**GEOLOGIC HAZARD REPORT VALIDTION
PARCEL NO. 63200-03-002
1210 EAGLE ROCK ROAD
LOT 1, RILEY SUBDIVISION
COLORADO SPRINGS, COLORADO**

Subject: 1210 Eagle Rock Road, STM-REV25-0558
Colorado Springs, El Paso County, CO, CGS Unique No. EP-25-0079

The Colorado Geological Survey (CGS) has reviewed the resubmitted documents for the existing shotcrete wall at 1210 Eagle Rock Road in Colorado Springs. The applicant requests a variance for a shotcrete-stabilized slope that was constructed without obtaining a permit during the original building construction in 2003. With this resubmittal, CGS received the updated hillside site plan (MVE, Inc., August 13, 2025).

MVE PROJECT 51564
MVE DRAWING HILLSIDE-PS
AUGUST 13, 2025
SHEET 2 OF 6

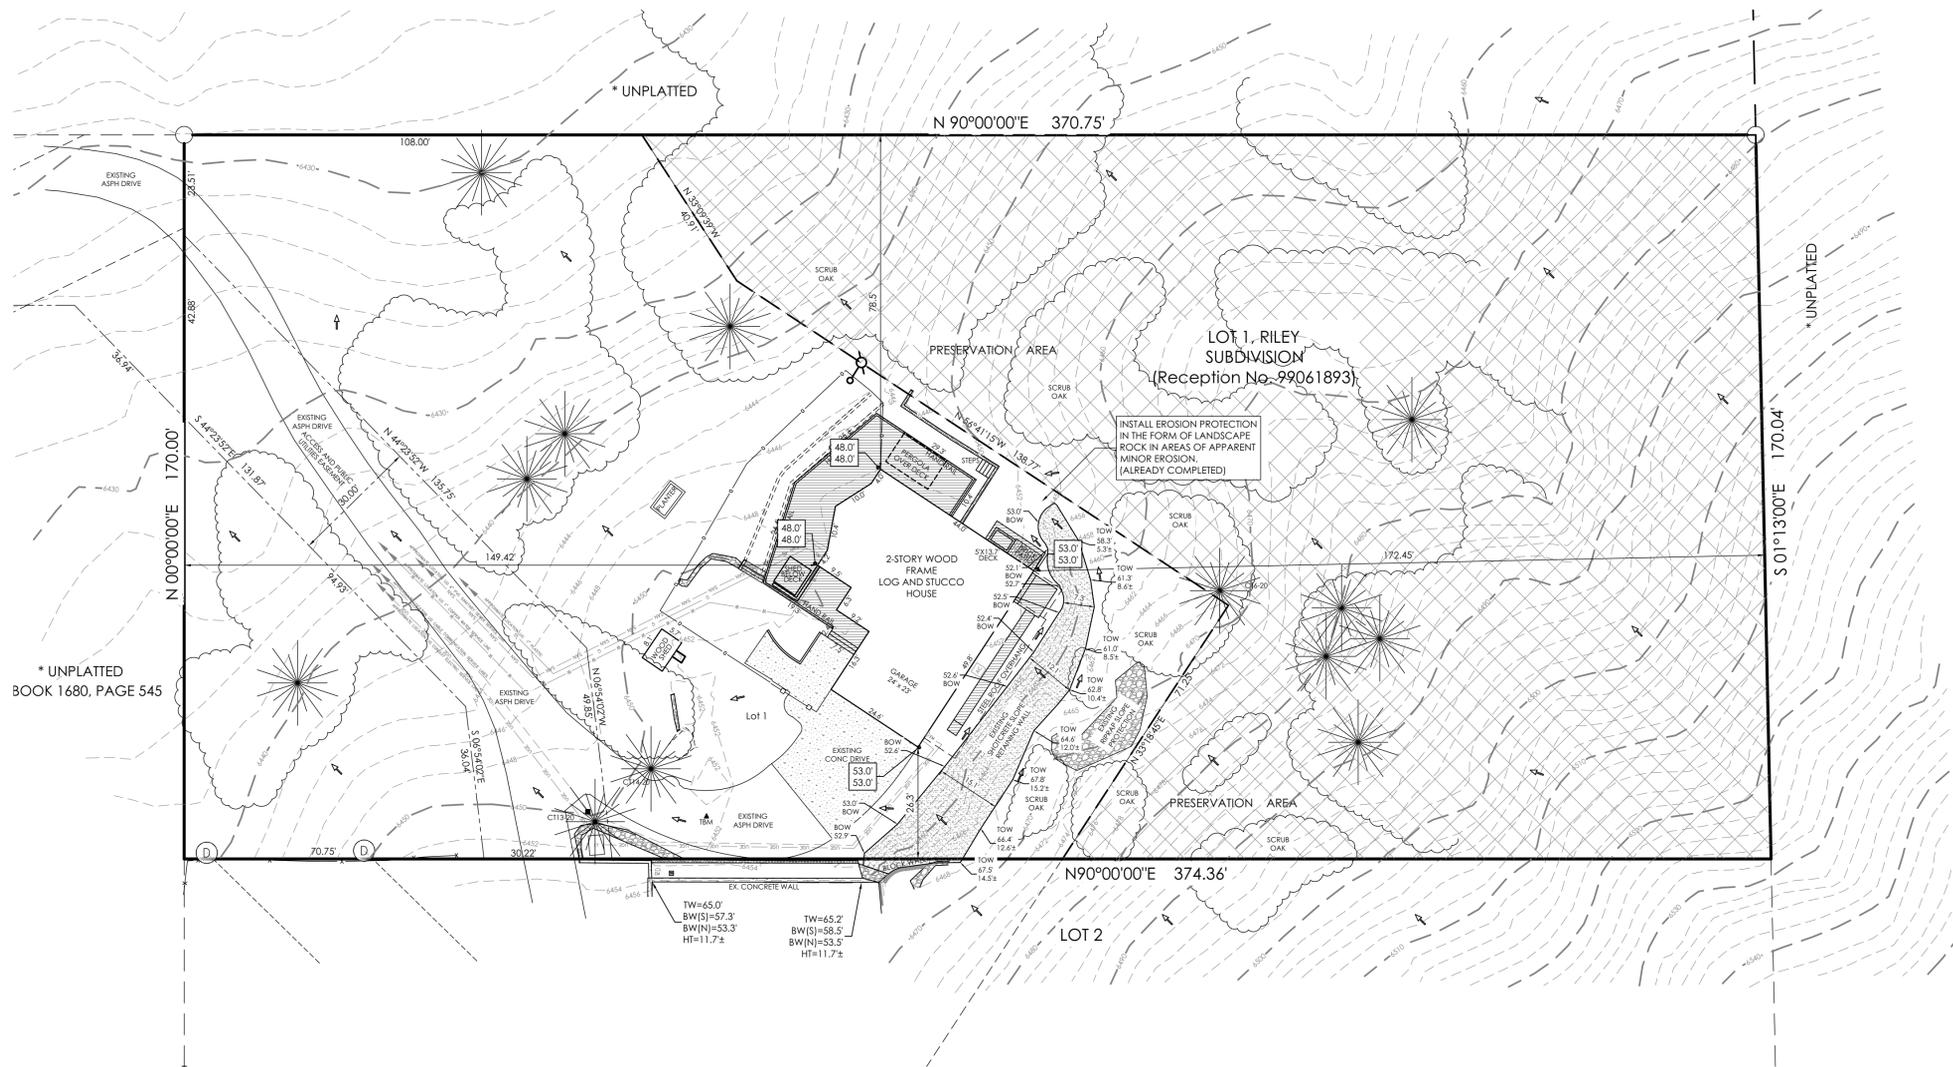
In our previous comment letter, CGS recommended that erosion control measures be presented in the site plan. As shown on the updated hillside plan, "Install erosion protection in the form of landscape rock in areas of apparent minor erosion (already completed)." CGS recommends that these measures be routinely maintained and replaced as needed.

Geologic Hazard Disclosure Statement: The geohazard disclosure statement is provided on the hillside plan, however, Entech's report referenced should be May 29, 2025 (not 2023). Erosion should be listed as a geologic hazard/condition in the statement.

Provided the geohazard disclosure statement is updated, CGS has no further comments regarding the variance of the shotcrete-stabilized slope submittal.
